CHILDREN'S HOSPIT.
OF ORANGE COUNT

TOWER II

LOWER LEVEL
REFLECTED CEILING PLAN
AREA - A

A4.0A

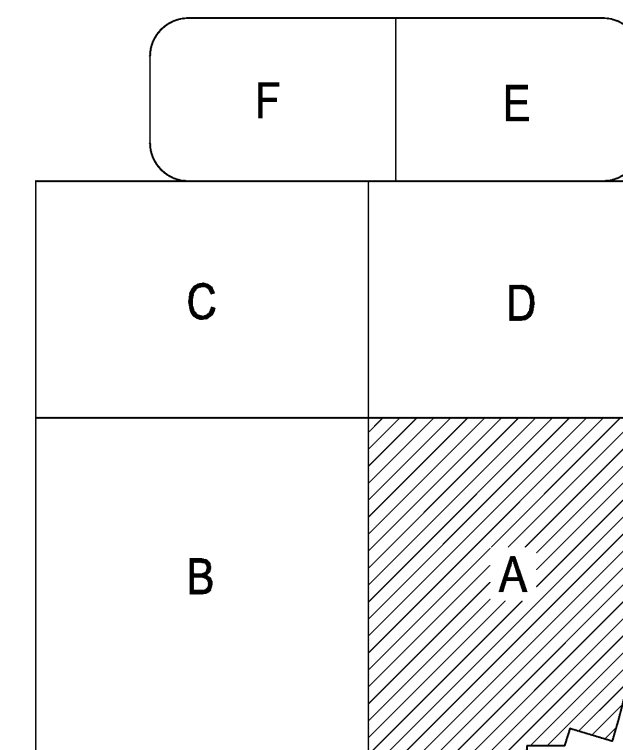
RFI 4115
See revised layout for
Lower Level access
doors.H

RFI #5472
LL RCP Coordination

RFI #4115.1
See revised layout for
LL access doors.
